**NCDOT Prestress Standard Repair Procedure for Non-Conformance Report (NCR)
SRP-05: Bottom Spalls at Girder End for Prestressed Concrete Girders– 04/05/2022**

Standard Repair Procedures – In-plant Repairs Only

Structures Management Unit Review Comments

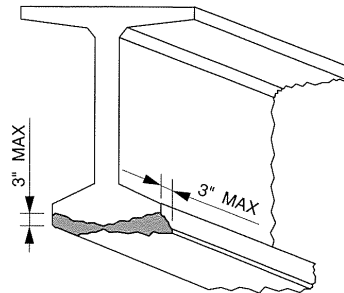
These standard procedures will only be applicable for corner spalls that have the following characteristics:

1. 3" maximum depth. (See photo below)
2. Steel may or may not be exposed.

- Provide sawcut a minimum of 1" beyond the perimeter of the repair area, to a minimum depth of $\frac{1}{2}$ ".
- Remove all unsound concrete within the repair area. Remove all concrete – unsound and sound – within the sawcut to a minimum depth of $\frac{1}{2}$ ".

- If more than half the circumference of a reinforcing bar is exposed, remove additional concrete to 1" behind the bar. This does not apply to prestressed strands.

- For areas in which no steel is exposed, use adhesively anchored anchors, with a minimum $\frac{1}{4}$ " diameter, spaced at 6" grid, and a minimum 2" embedment into member, to provide mechanical bond for repair material. Provide the design concrete cover for studs.

- Do not damage rebar or strand.
- Form and place repair material to original shape.
- The repair material shall have a minimum compressive strength equal to or greater than that of the original beam concrete.

- The maximum size of aggregate in repair material should not exceed $\frac{2}{3}$ of the minimum depth of the repair area.
- The repair material shall be on the NCDOT Approved Products List.

- Surface preparation, proportioning, mixing, placement, and curing of repair material should follow all manufacturer's recommendations.
- Perform repair operations in the presence of and to the satisfaction of the on-site NCDOT inspector.
